PLANNING COMMISSION MEETING

LOCATION: TOWNSHIP ANNEX, 7527 HIGHLAND ROAD, WHITE LAKE, MI 48383
THURSDAY, JUNE 20, 2024 – 6:30 PM

Project Name: West Valley
 Description: Final site plan re-approval
 Date on Agenda this packet pertains to: June 20, 2024

RE: West Valley – Final Site Plan and Final Engineering Plan – 9th Review

IRR-5 of 6

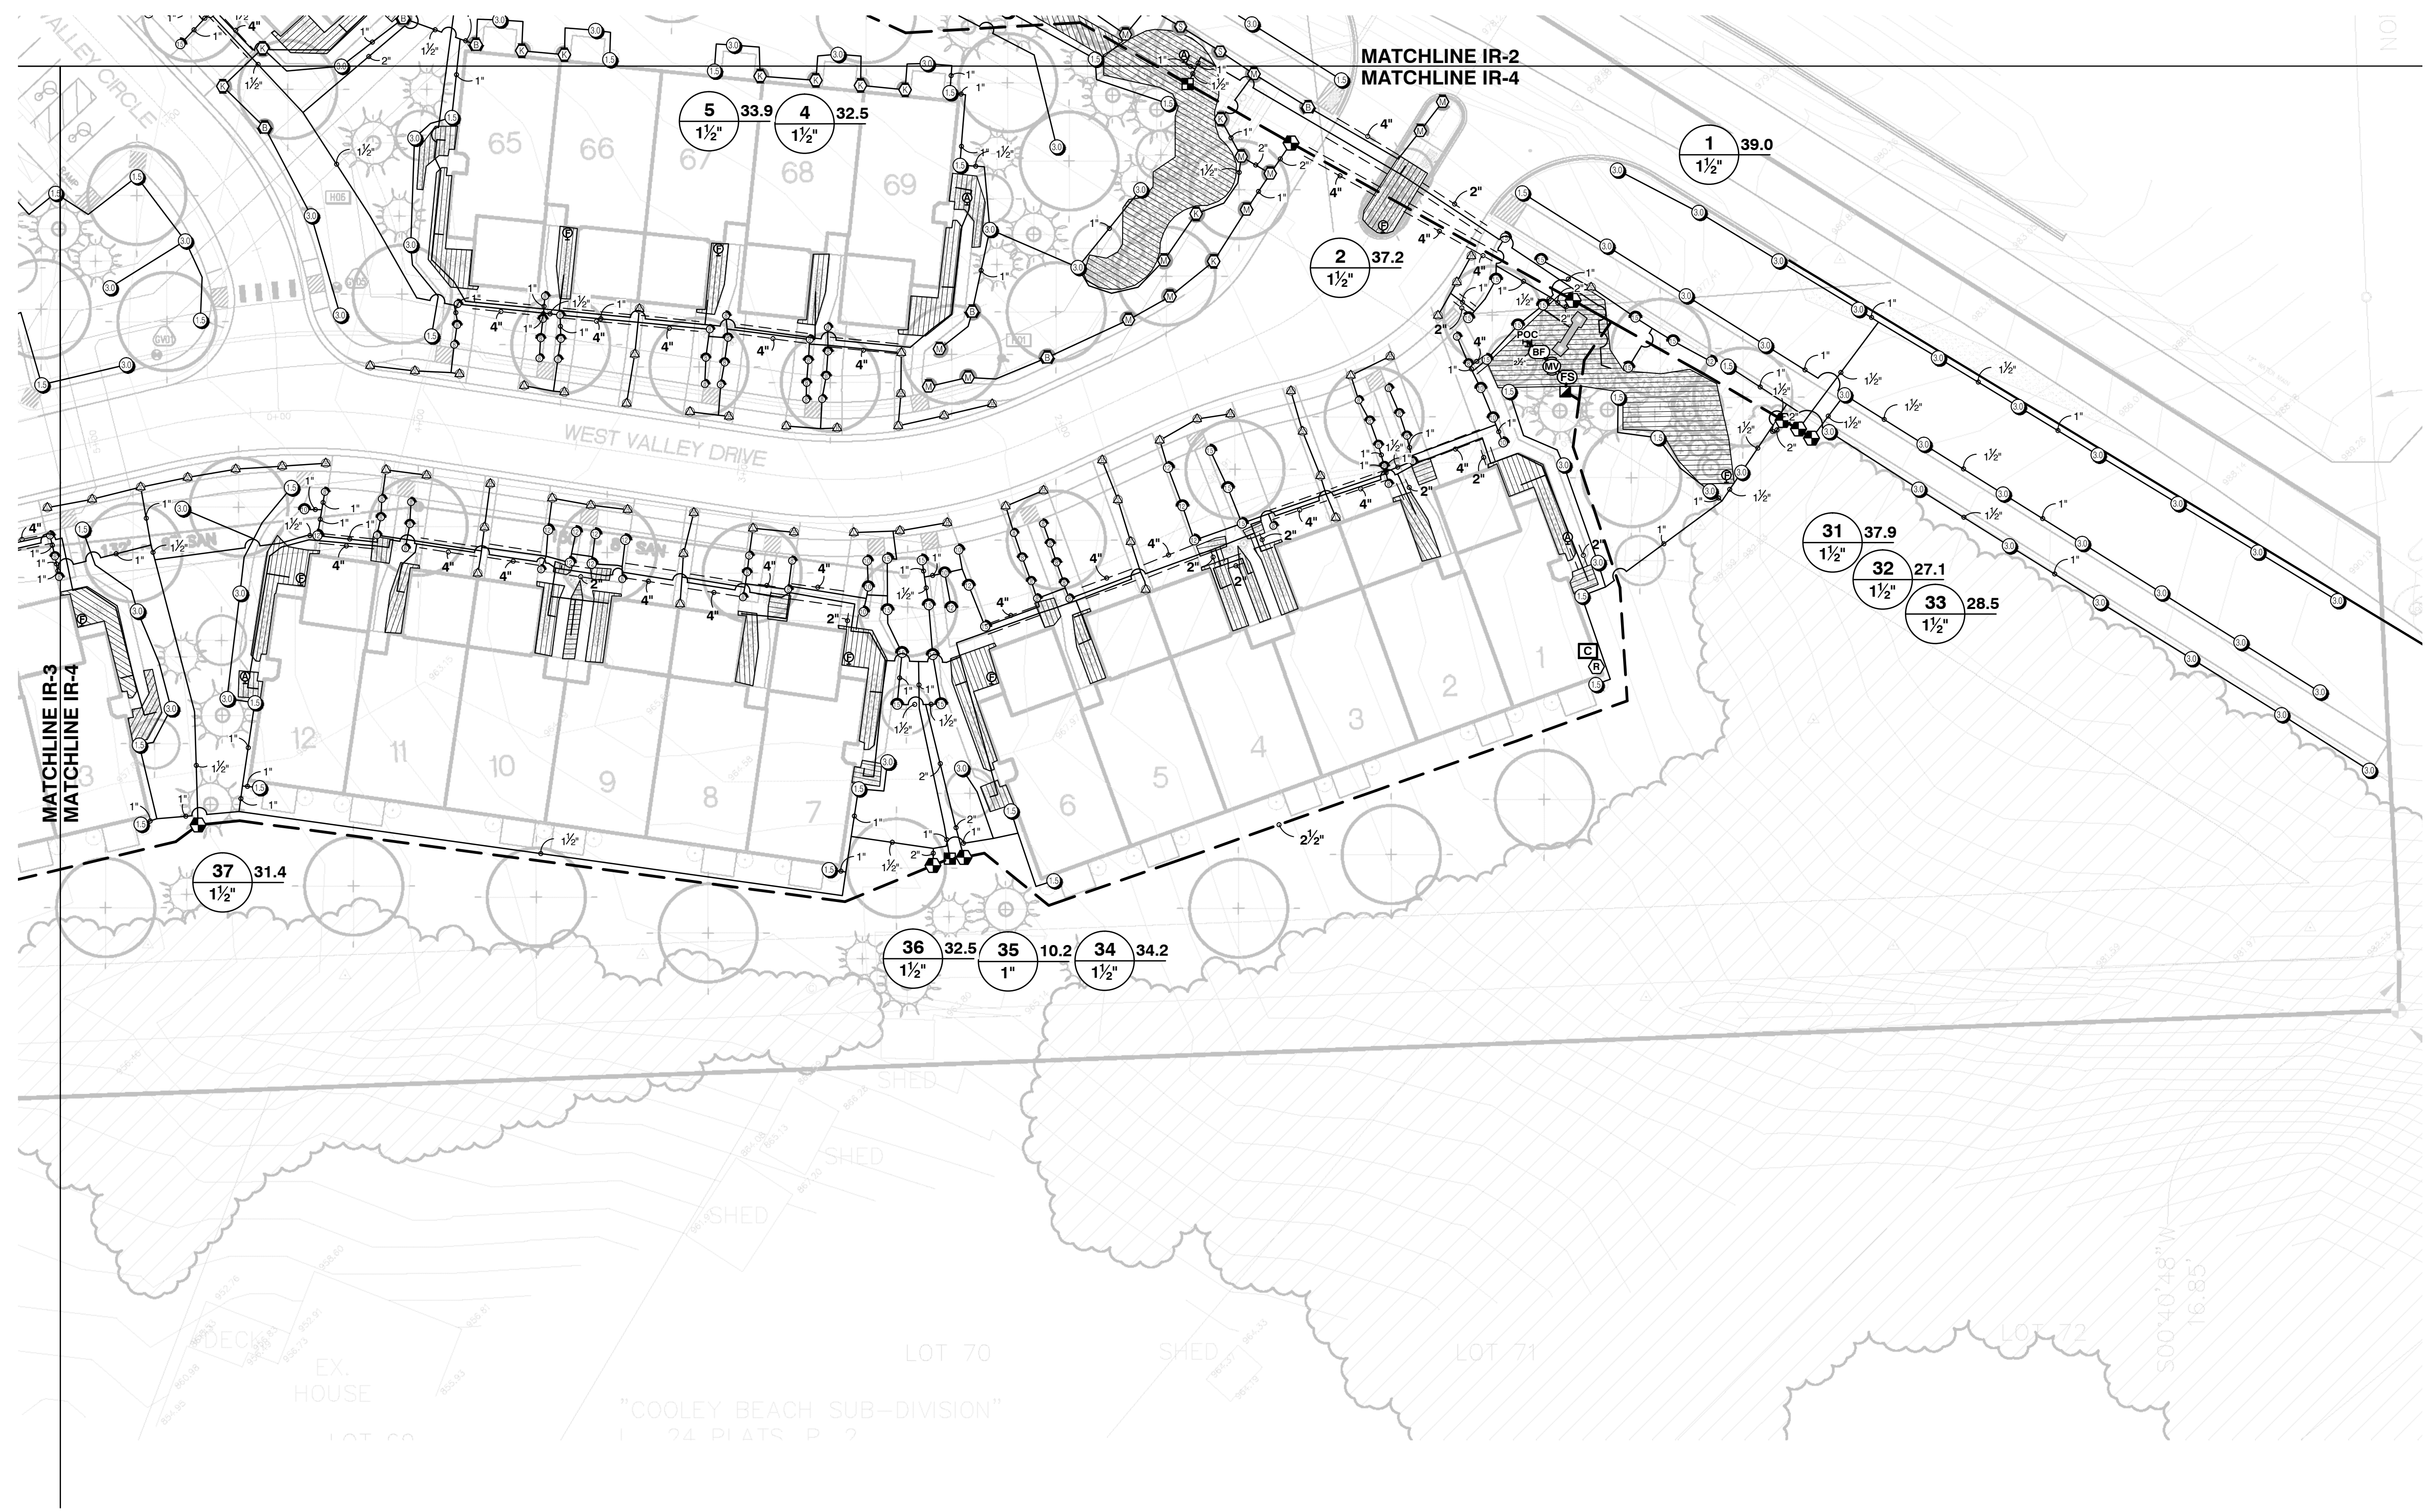
1. Revision dates for Sheets IRR 1 through 6 have been corrected to reflect May 29th, 2024.
2. Sheet LS 5 has a note stating “*All site irrigation systems shall include a rain sensor or similar measure to ensure irrigation down not occur during or shortly after precipitation events.*” It is likely “*down*” is an error and is intended to state “*does*”.
